TMC SPECIFICATION NO. S-594

TITLE: SBE-3 ALDC MODIFICATION KIT (TMC NO. KIT-110)

To provide an ALDC line into the SBE-3.

FIGURE 1*

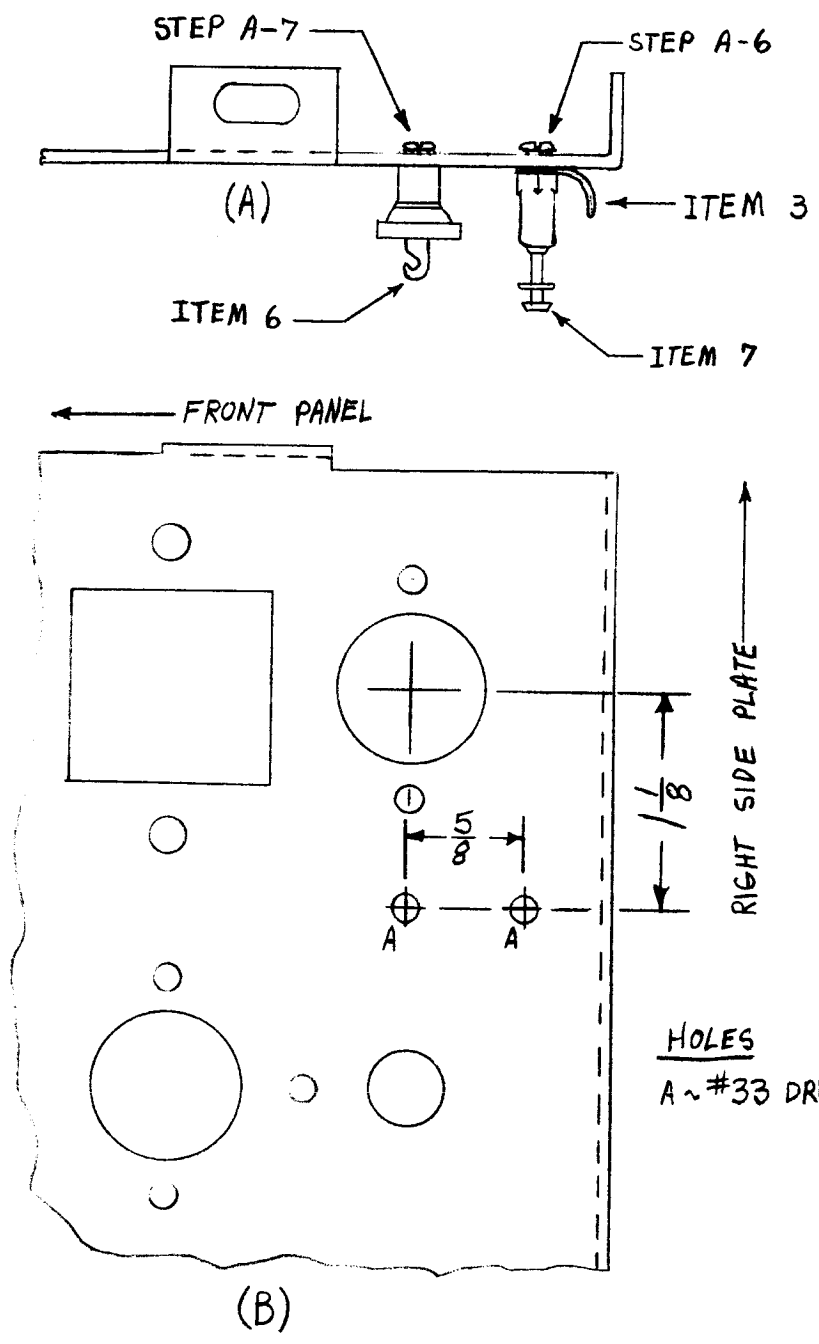
- A. With the SBE-3 on the bench and all power disconnected, the following procedure is to be followed.
 1. Remove top and bottom dust covers.
 2. Unsolder the grounded ends of R192 and R193.
 3. Mark appropriate spot on the chassis, for the drilling of the two holes used for mounting of the turret terminal and button capacitor (hole locating dimensions shown in Figure 1).

5. Clean SBE-3 of all metal shavings resulting from the drilling. Be sure that nothing is shorting.
6. Mount the turret terminal (Item 7) and locking terminal lug (Item 3) by use of the 4-40 hardware (Items 8 & 10) as shown in Figure 1.

7. Mount the button capacitor (Item 6) by use of the 3-48 hardware (Items 9 & 11) as shown in Figure 1.
8. Slide the proper amount of insulation (Item 12) over the loose ends of R192 and R193 and connect each resistor to the button capacitor (Item 6). Do not solder.

FIGURE 2
COMPONENT LAYOUT

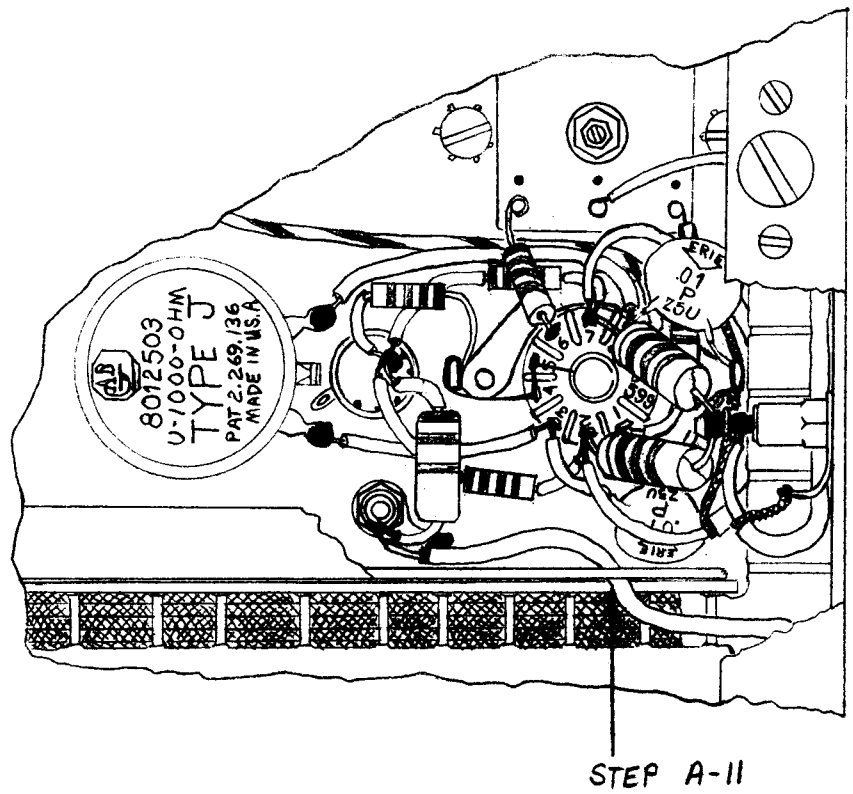
11. Insert RF cable (Item 1) through hole found on RF shield wraparound as shown in Figure 2.
12. Connect center conductor of RF cable to turret terminal (Item 7). Solder the connection.

18. Affix instruction nameplate (Item 15) directly to the left of the connector which has just been installed (Refer to Figure 3).
19. Check modifications to see that everything conforms with Figure 2.

FIGURE 3*
HOLE LOCATING VIEW

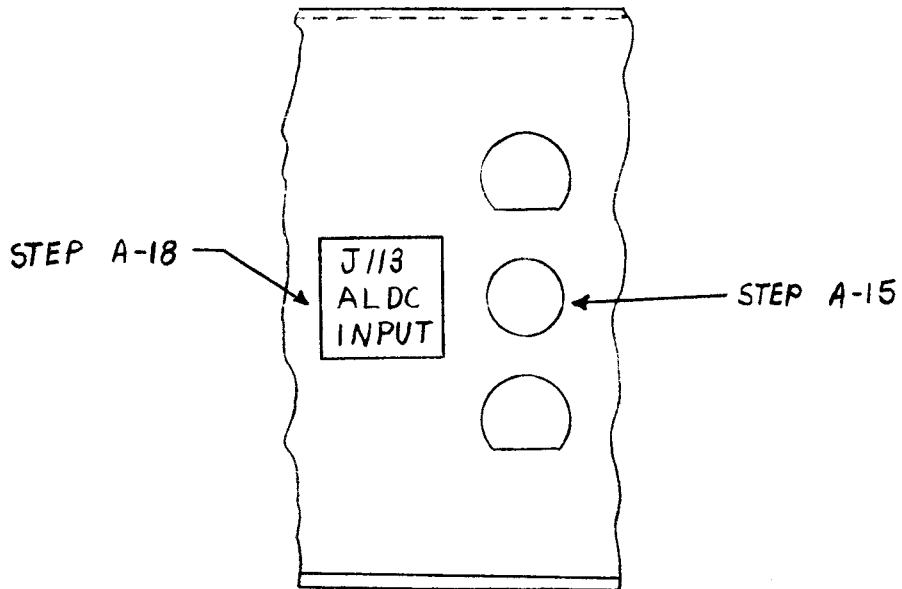
15. Mount the RF connector (Item 2) in the hole found between J111 and J112 as shown in Figure 3. Mount the solder lug (Item 16) over the rear of the RF connector. Proceed now to tighten the locking nut by use of the 1/2 inch open end wrench.

FIGURE 4
 SCHEMATIC CHANGES

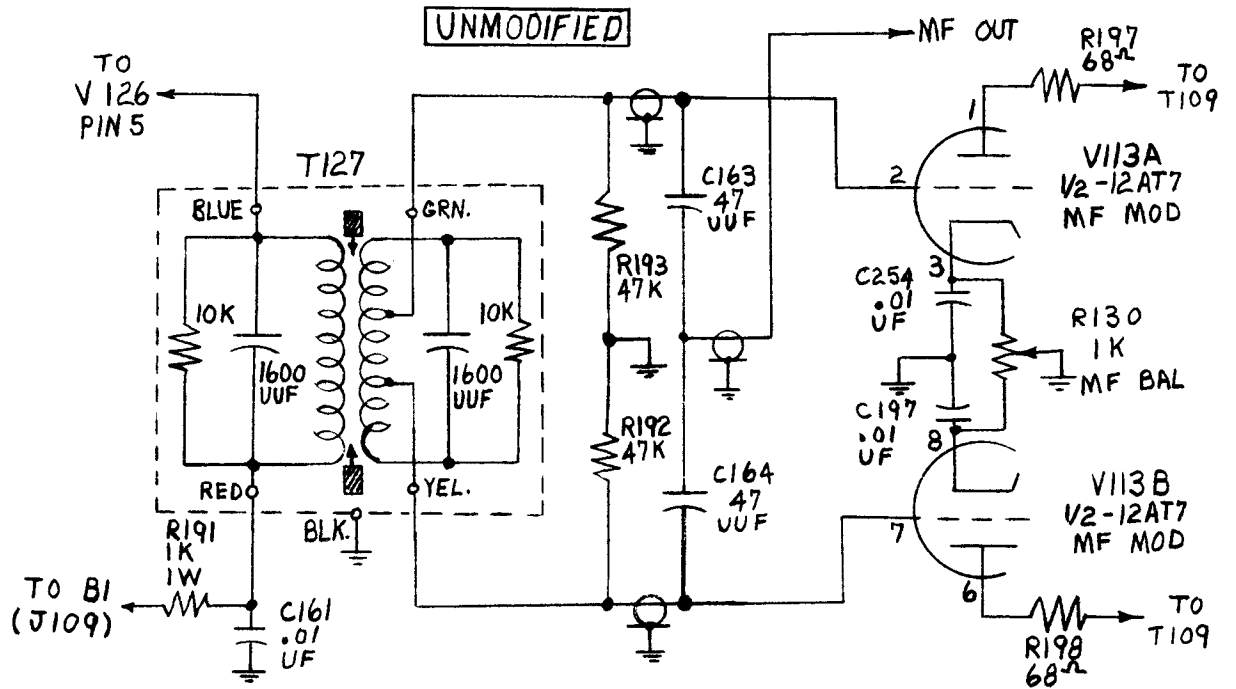
20. See Figure 4 for schematic diagram.
21. Replace the top and bottom dust covers, after the SBE-3 has been inspected for proper installation of the ALDC modification.
